UNITED STATES PATENT AND TRADEMARK OFFICE

APPLICATION NO.	FILING DATE	FIRST NAMED INVENTOR	ATTORNEY DOCKET NO.	CONFIRMATION NO.
10/539,148	06/16/2005	Morgan Kanflod	AC-100	9266

Office Action Summary	Application No. 10/539,148	Applicant(s) KANFLOD ET AL.	
	Examiner VICTOR MACARTHUR	Art Unit 3679

DETAILED ACTION

*Fig. 2*

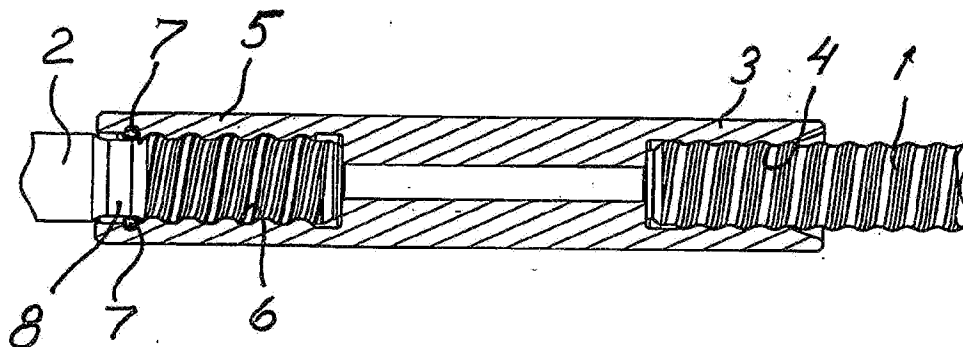
Claims 1 and 2 are rejected under 35 U.S.C. 112, first paragraph, as containing subject matter which was not described in the specification in such a way as to reasonably convey to one skilled in the relevant art that the inventor(s), at the time the application was filed, had possession of the claimed invention. Applicant has not pointed out where the newly added limitation "said locking device is loaded to retain the rock drilling machine connected to the coupling sleeve only when said rock bolt is disconnected from said coupling sleeve..." (lines 9-11 of claim 1) is supported, nor does there appear to be a written description of the claim limitation in the application as filed such that this newly added limitation constitutes new matter. Note that applicant's figure 2 (reproduced below) clearly shows the locking device spring pins (7) loaded against a taper of the rock drilling machine (2) in a condition when the rock bolt (1) is not disconnected from the coupling sleeve (3, 5). In fact even if figure 2 depicted locking device (7) to be unloaded (although it appears loaded) there is no structure to prevent the loading of device (7) when the machine (2) is removed from the sleeve (3, 5) regardless of whether or not rock bolt (1) is connected or disconnected.

Note that MPEP §2173.05(i) clearly states that “Any negative limitation or exclusionary proviso must have basis in the original disclosure” and while it is true that “if alternative elements are positively recited in the specification, they may be explicitly excluded in the claims... The mere absence of a positive recitation is not basis for exclusion. Any claim containing a negative limitation which does not have basis in the original disclosure should be rejected under 35 U.S.C. 112, first paragraph, as failing to comply with the written description requirement”.

The examiner notes that the last paragraph on p.2 of applicant’s original written description states “During drilling the locking device 7 is unloaded. After drilling the rock bolt 1 is to be separated from the coupling sleeve and left in the rock. Hereby the rock drilling machine is rotated for loosening of the thread connection.” However a positive statement that the locking device is not loaded during drilling does not provide antecedent basis for a negative limitation “loaded... only when said rock bolt is disconnected” since applicant locking device (7) can clearly be loaded during removal of machine (2) regardless of whether or not bolt (1) is connected or disconnected.

*Fig. 2****Claim Rejections - 35 USC § 103***

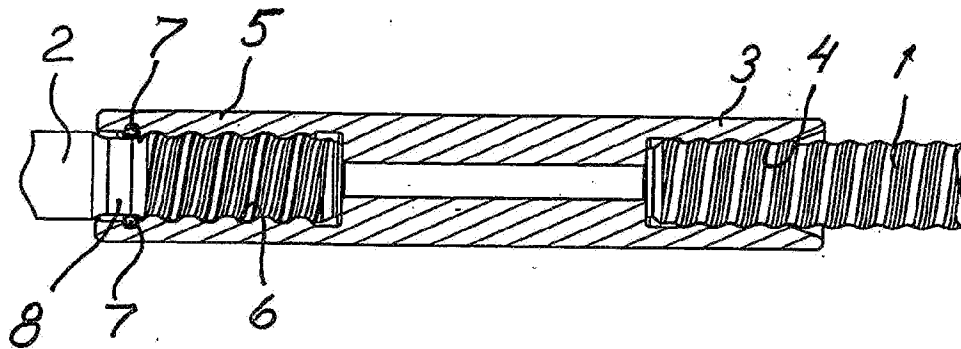
It is unclear how “said locking device is loaded to retain the rock drilling machine connected to the coupling sleeve only when said rock bolt is disconnected from said coupling sleeve...” (lines 9-11 of claim 1). Particularly, what structure would prevent loading of locking device (7) when rock drilling machine (2) is removed from sleeve (5, 3) while rock bolt (1) remains connected to sleeve (5, 3)? Does applicant mean for the limitation as merely one possible intended use rather than a structurally limiting feature of the product? See applicant’s figure 2 below.
